Hillingdon

Outline Fire Strategy – Rev E

OF-OFS-3671-01-E

Appendix A – Drawing Comments

4 Building 6 - Fifth to Seventh Floor Plan

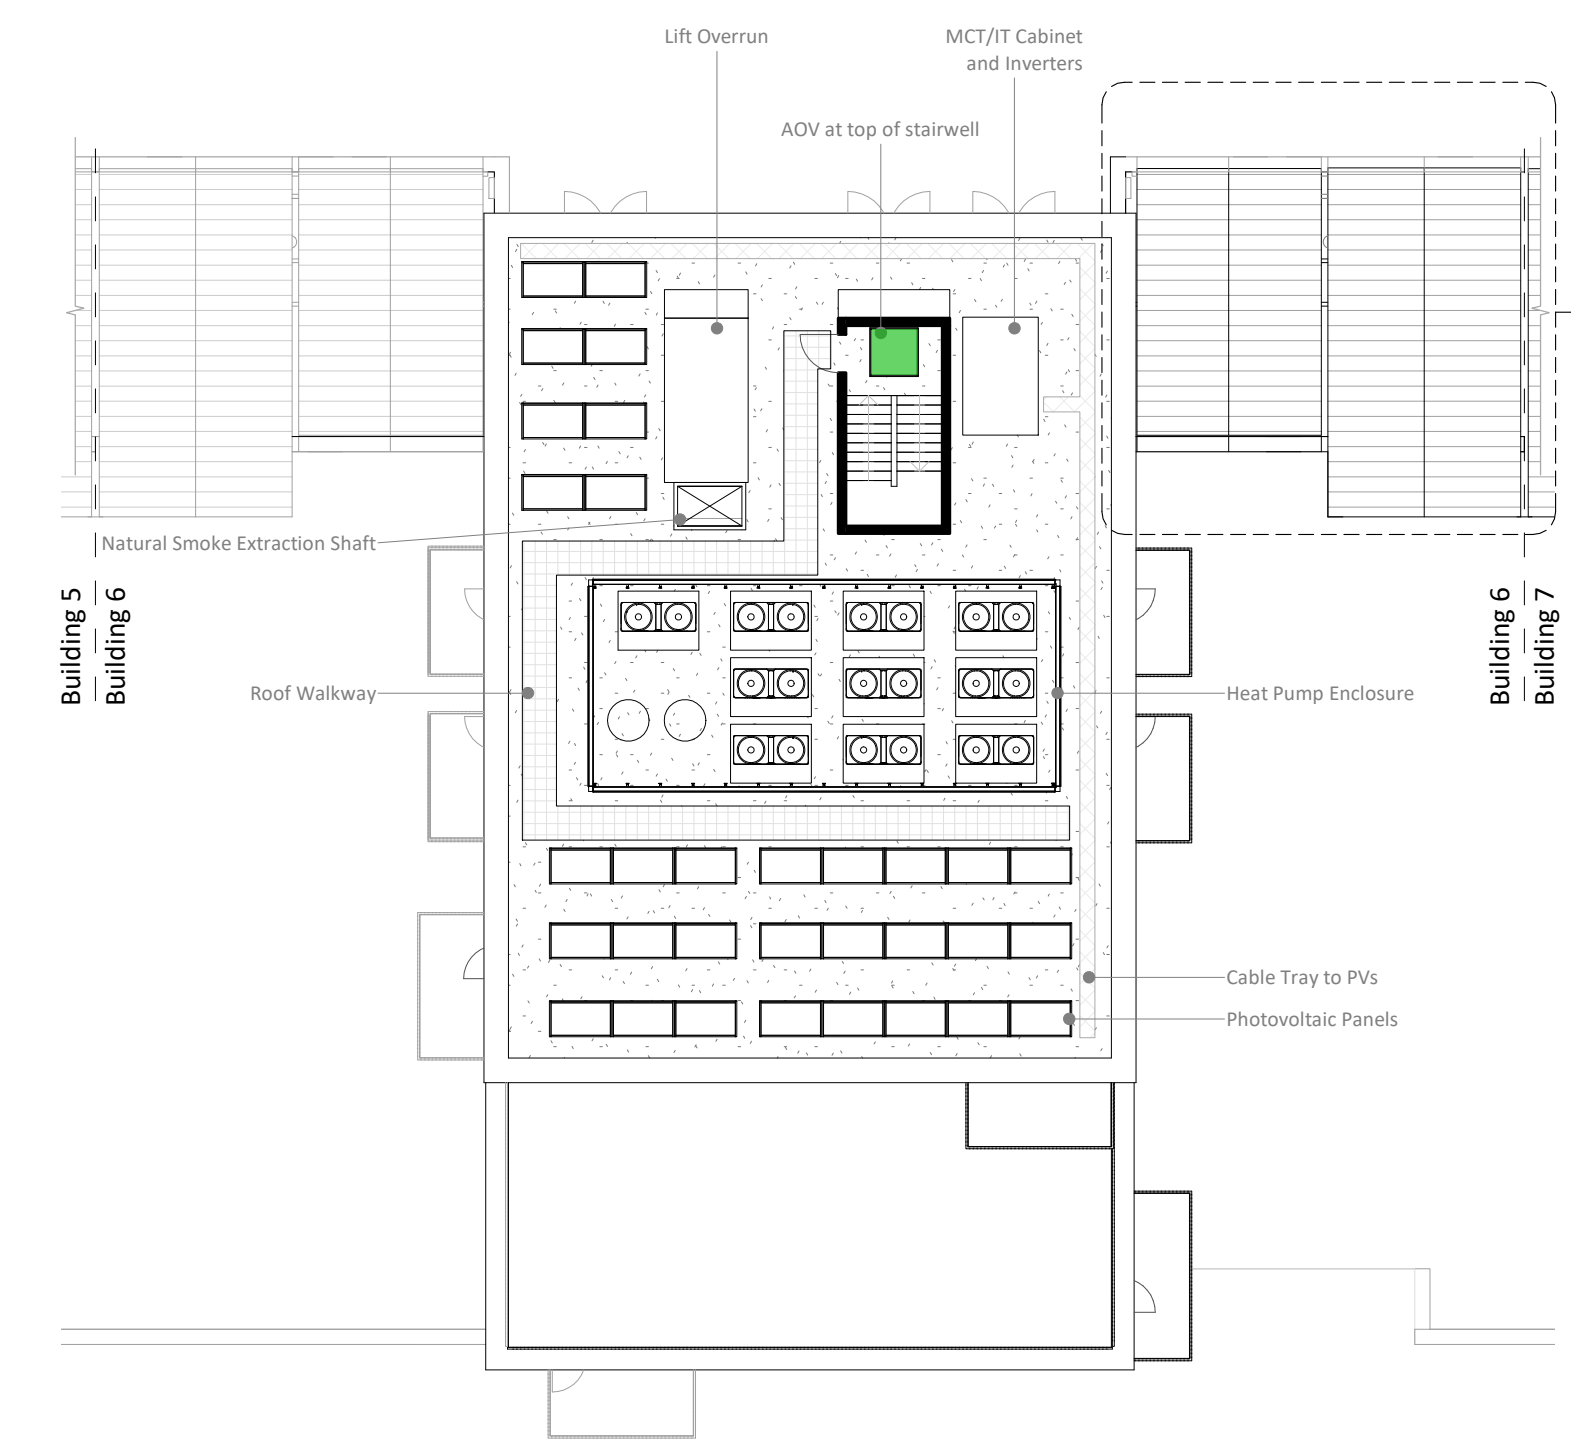
To be noted, if the service riser is to only contain water services or metal ventilation ductwork from the ground floor, it is considered a limited fire hazard. As such, this riser shaft may be located in the staircase lobby.

To be noted, the government have stated from May 2020, all new building's over 11m in height are required to be provided with sprinklers, see Section 9.

1 Building 7 - Ground Floor Plan
1 : 200

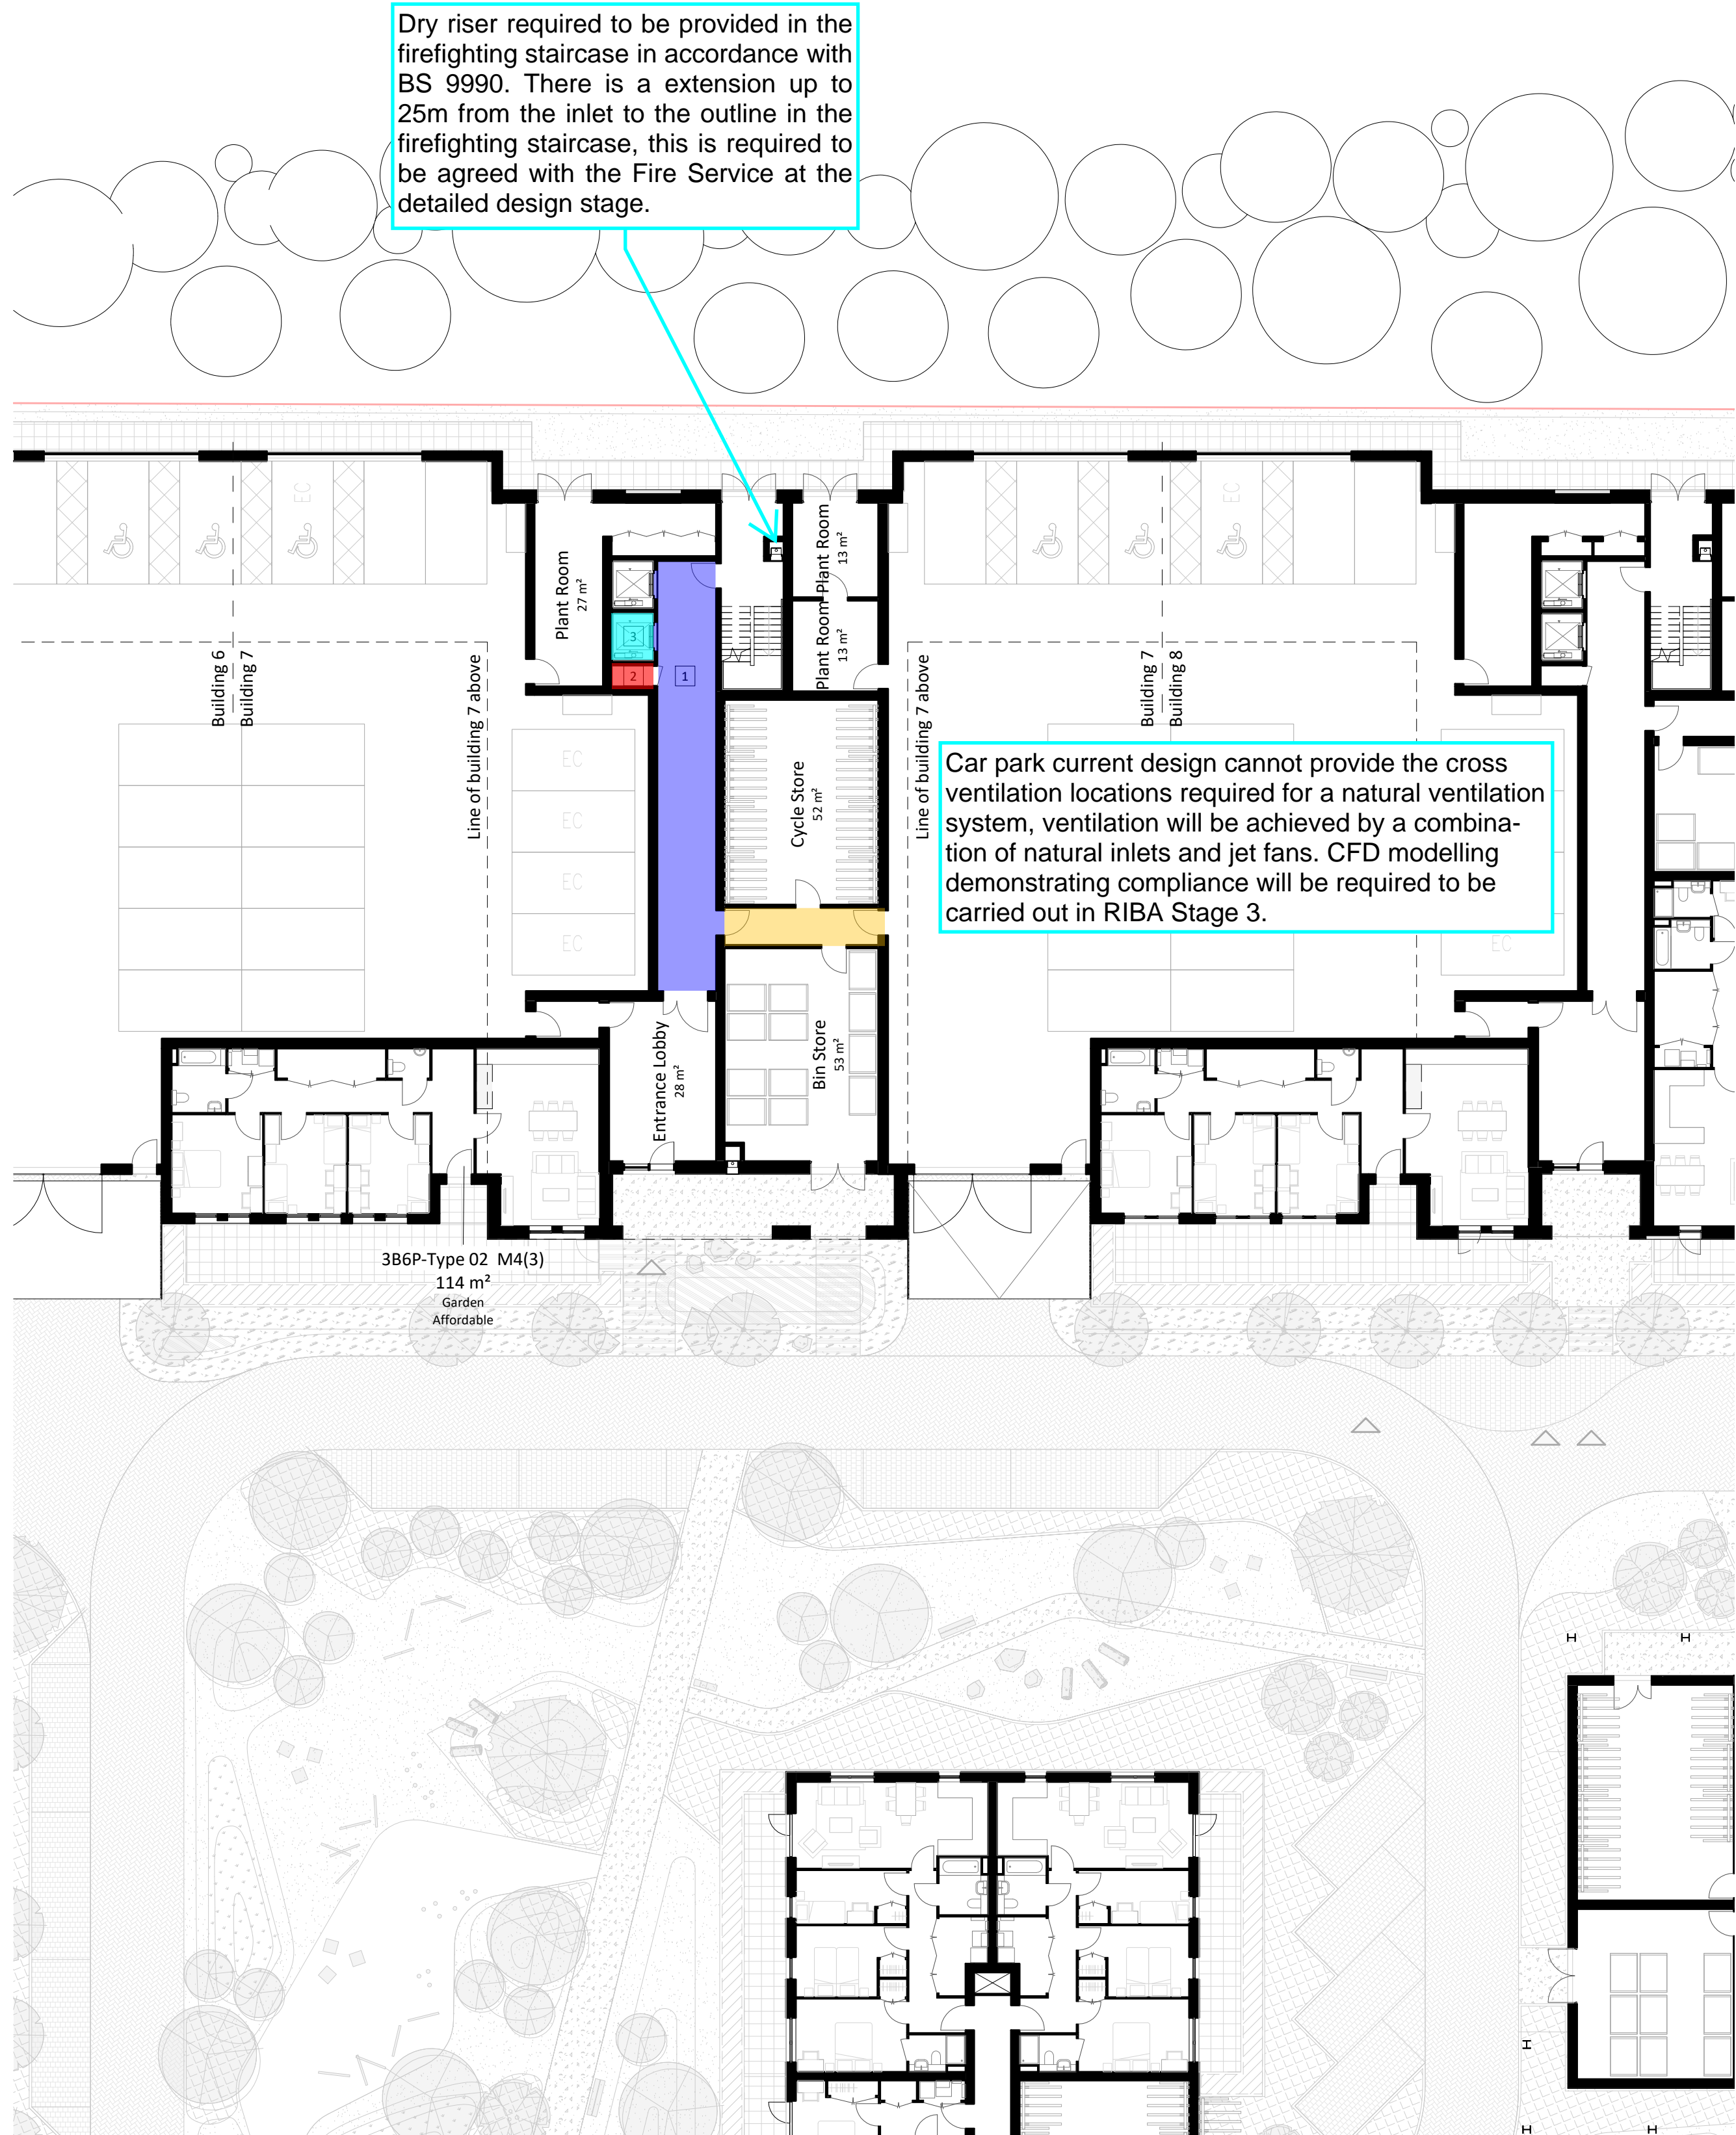
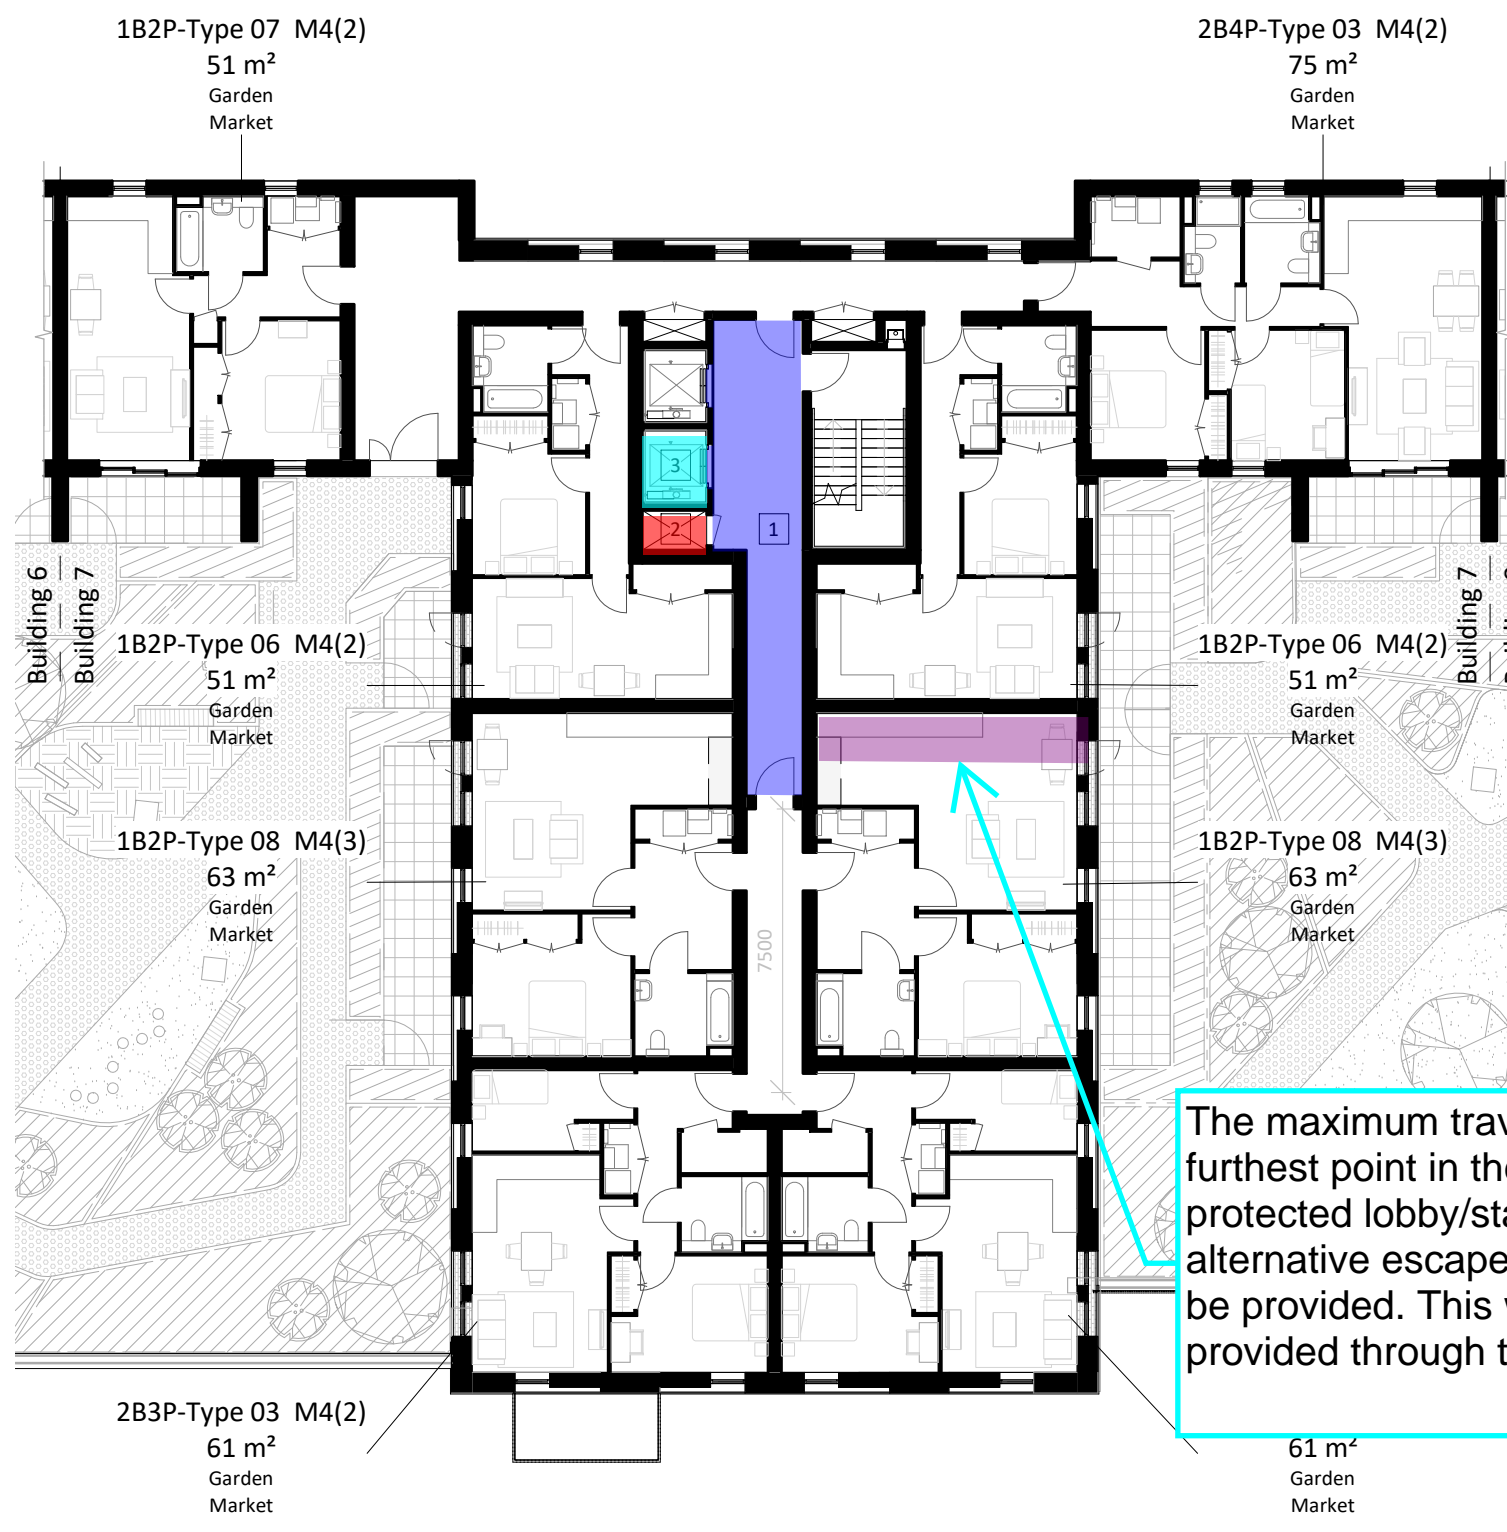
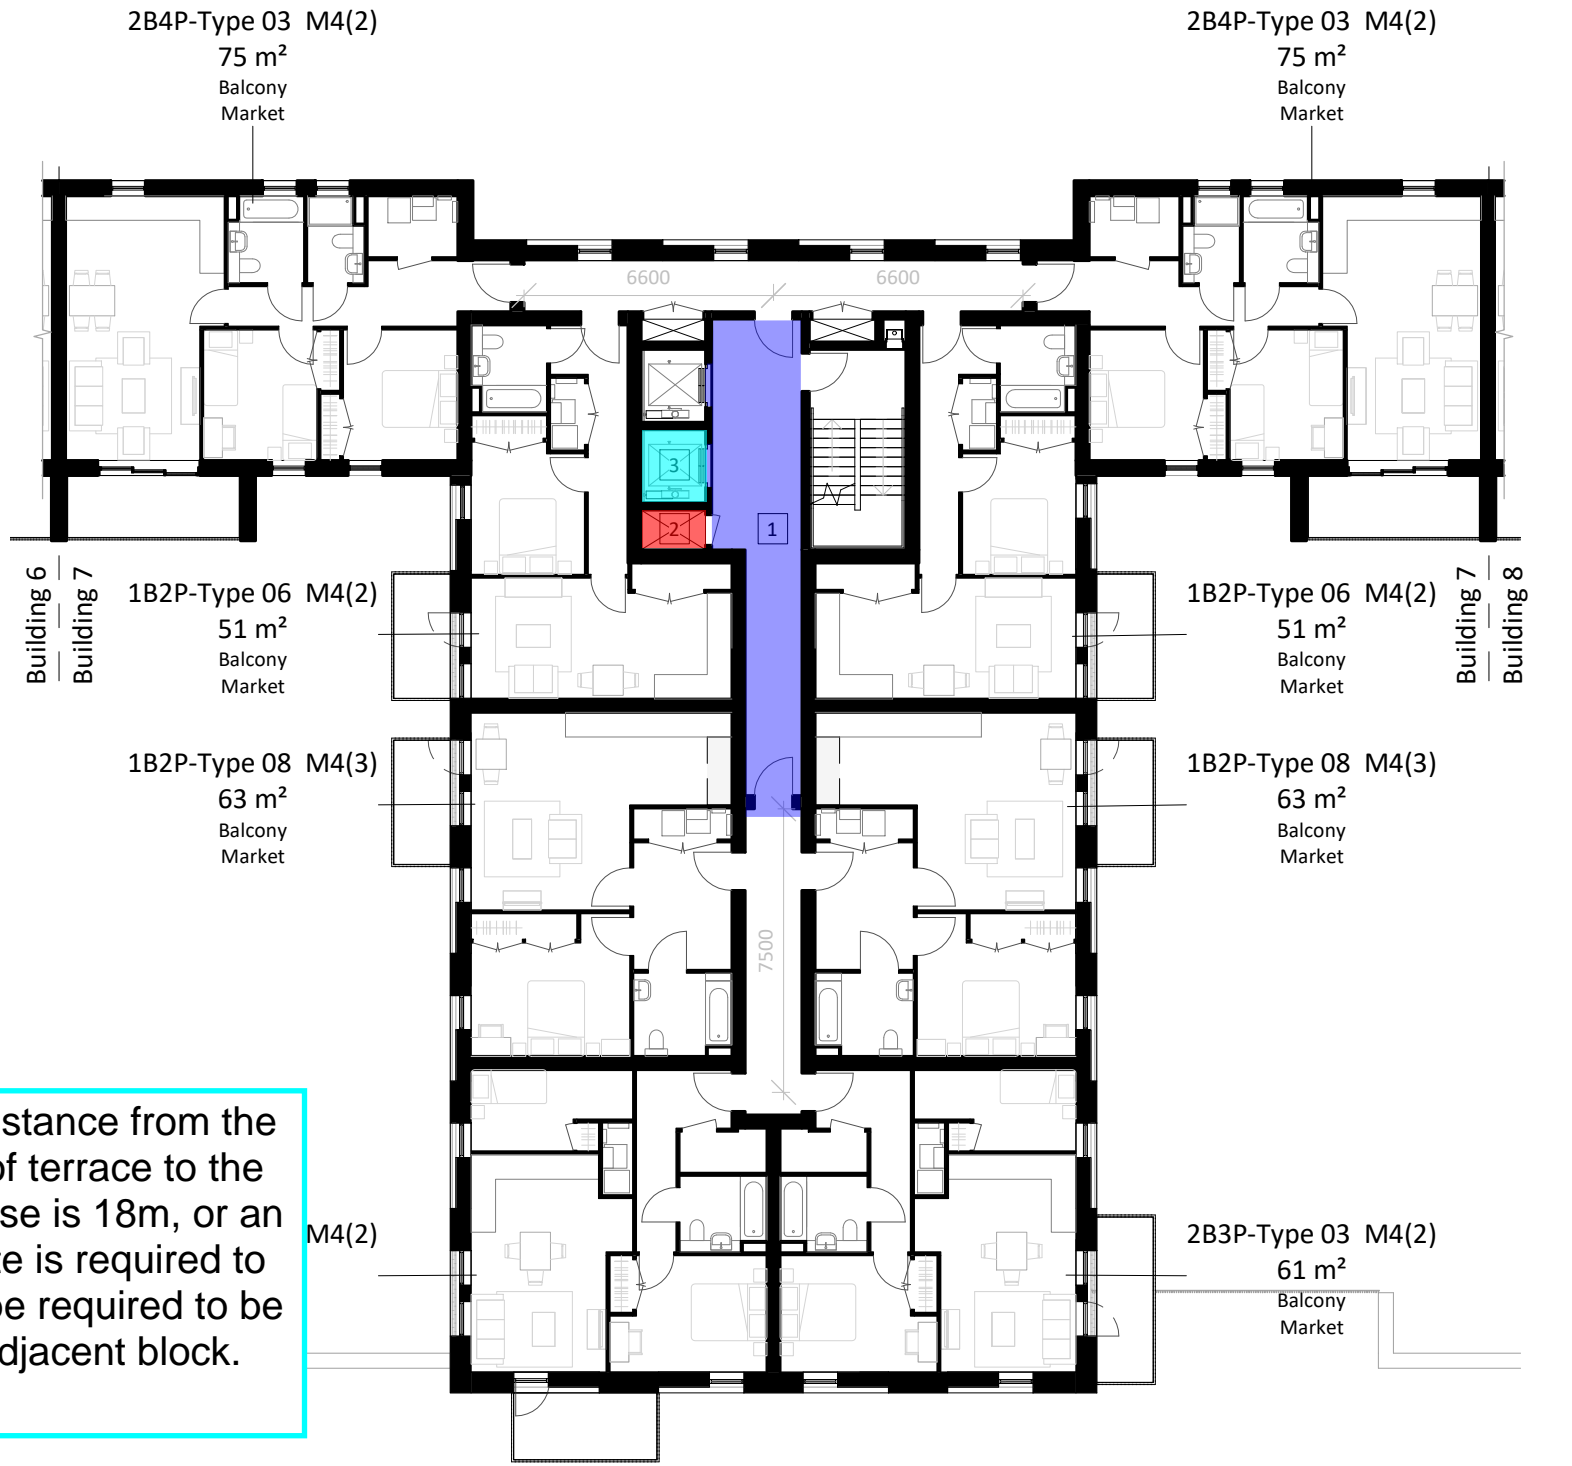
To be noted, the government have stated from May 2020, all new building's over 11m in height are required to be provided with sprinklers, see Section 9.

To be noted, if the service riser is to only contain water services or metal ventilation ductwork from the ground floor, it is considered a limited fire hazard. As such, this riser shaft may be located in the staircase lobby.
